CERTIFICATE OF APPROPRIATENESS PLACARD

630 N BLOUNT STREET

Project Description:

Raleigh Historic Development Commission – Certificate of Appropriateness (COA) Application

630 N. Blount Street - Landscape Plan

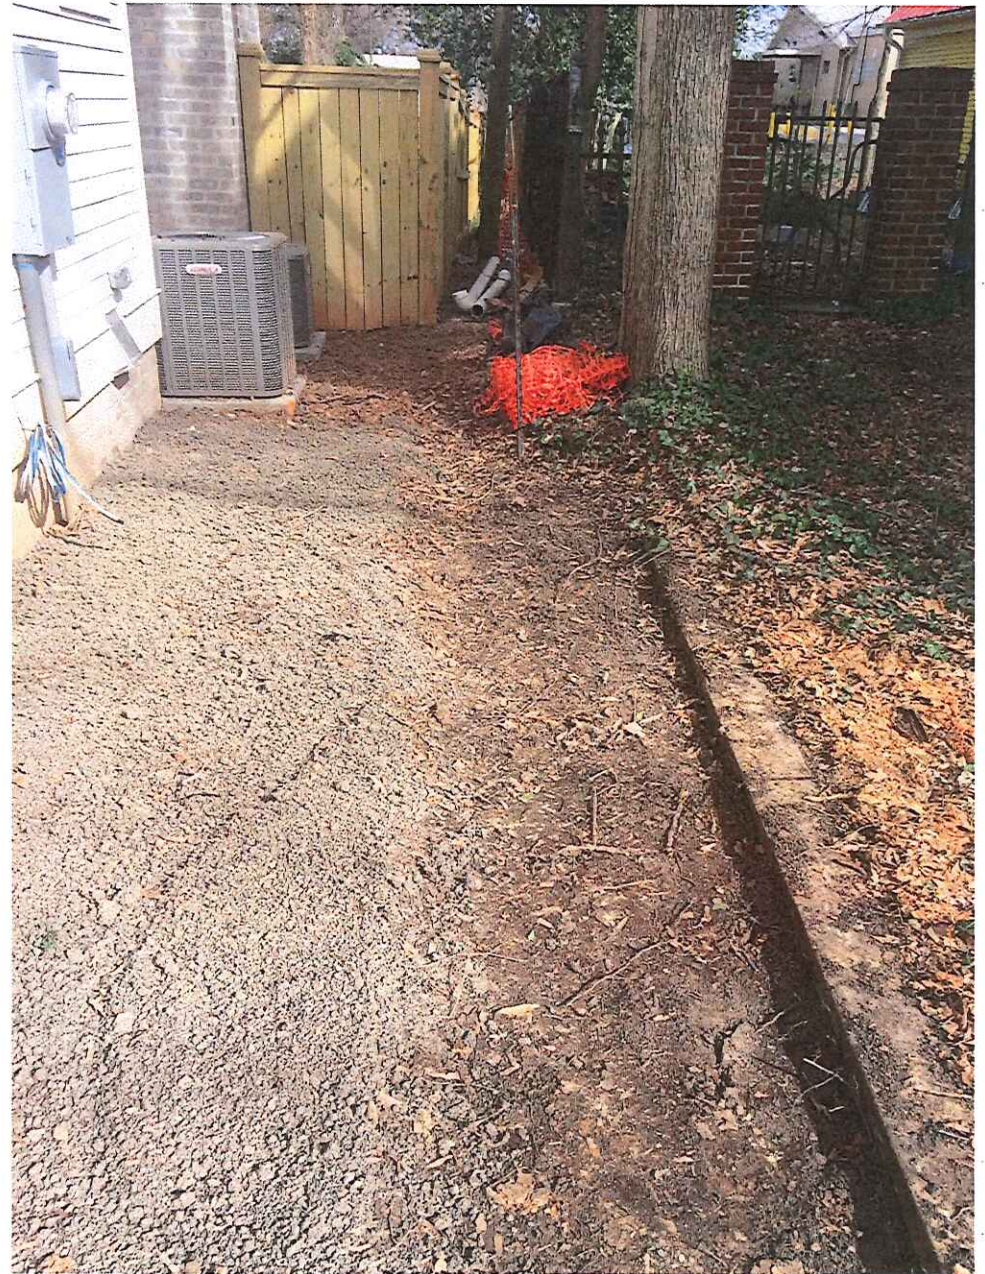
C = ^{Keep} ~~Nellie Stevens Holly~~ ~~Change~~ ^{ADD} to Needlepoint Holly per 3/10/15 email.

For the Hollies, being more specific about the number may help. Your sketch makes it appear as though there will be a wall of holly trees along the N property line. How many trees are you actually proposing to plant? Those that are behind the front wall of the house do not have a height issue. Any planted forward of the front wall of the house should be more shrub height (42" to 48") or fewer in number.

- Looking at the application, with the additional information requested above, most of it meets the guidelines and is approvable as a Minor Work. However, the proposed row of hollies along the north property line and boxwood hedge in the front yard does not clearly meet the guidelines.

- 2.4.11 "It is not appropriate to introduce walls or fences taller than 42" or that are more than 65% solid into the front yard area (and/or street side yard area of a corner lot)." The commission, on some occasions has interpreted shrubs as walls.

- 2.3.4 "Replace missing or deteriorated site features with new features that are compatible with the character of the site and the historic district."

- 1) From NW corner going East for 10' = Cluster of 1 Rhododendron and 3 Azalea.
- 2) From above material to area where driveway begins to taper to South on Plot Plan (about 15' East of front line of house) = 15 Needlepoint Holly with mature height of 36". This is about 40' along North side.
- 3) From above material to even with front line of garage = 6 Nellie Stevens Holly staggered. This is about 30' along North side.

- Regarding Boxwood mature height, the Boxwoods in the front yard will have a mature height of only 18"-24". The Boxwoods in the backyard would be a bit taller with mature height of 24"-36".

- Regarding the Boxwoods, we are not intending to create a wall. The mature height is no more than 24"-36". When we spoke yesterday, you said that my part of the district actually would be appropriate for a low hedgerow like the one we've suggested. Please advise.

PLOT PLAN

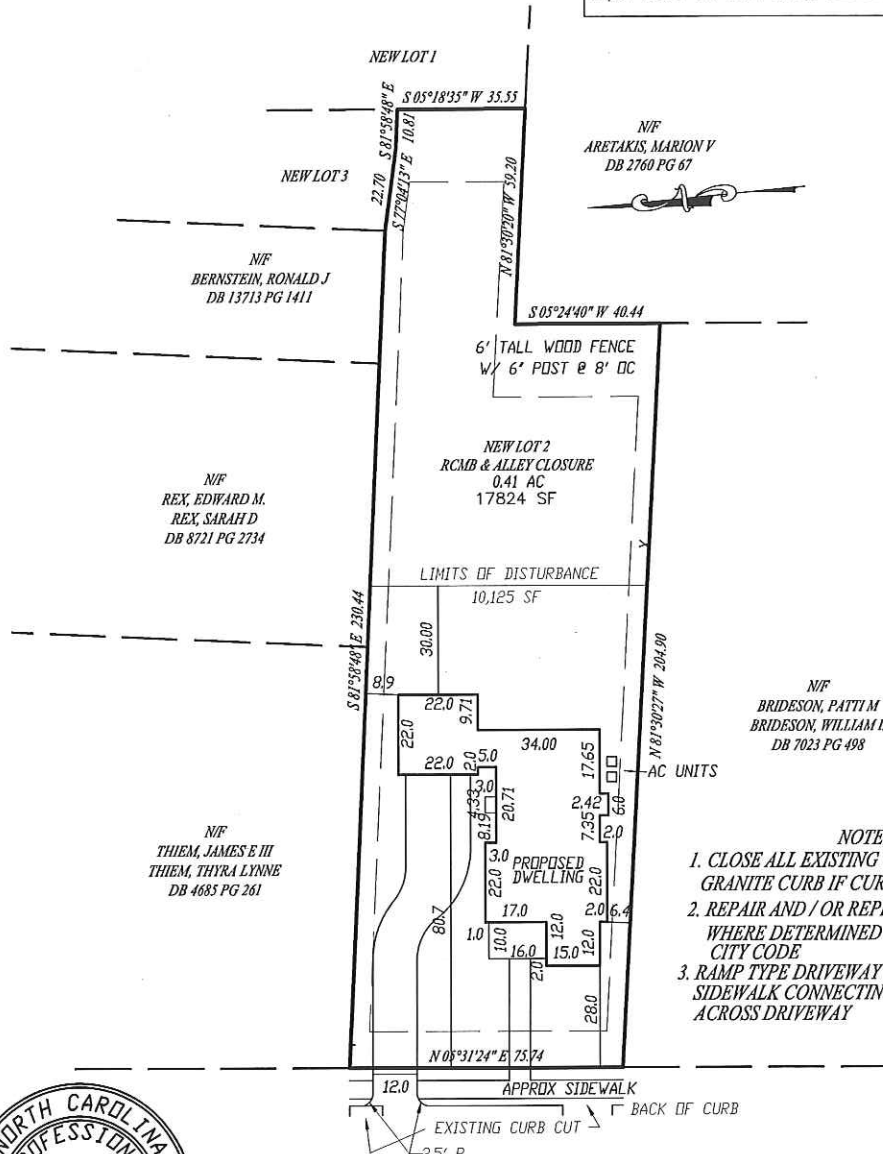
- What is the dimension of the pervious natural stone patio and how will the stone be installed?
- What are the mature heights of the proposed plantings around the perimeter of the property (C, A, E)?

- Attached are pictures of sides and back.
- The pervious stone patio: dimensions 36'x30'. Stones are simply laid on ground, no cement or structured base.
